**REQUEST**

Current Zoning: R-3 (single family residential)  
 Proposed Zoning: UR-2(CD) (urban residential, conditional) with five-year vested rights.

Approximately 3.49 acres located on the east side of Park Road, north of Sharon Road.  
 (Council District 6 - Bokhari)

The petition proposes redevelopment of four parcels containing three single family homes with a 20-unit, single family attached development along Park Road north of Sharon Road.

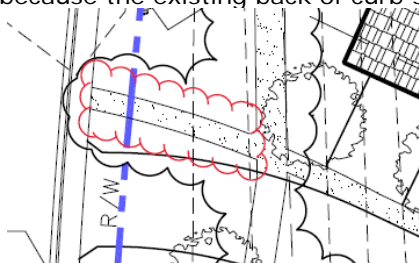
1. Remove the section of internal sidewalk, shown below, that is parallel to the northern most driveway between the proposed sidewalk along Park Road and the existing back of curb sidewalk because the existing back of curb sidewalk should be removed. Addressed
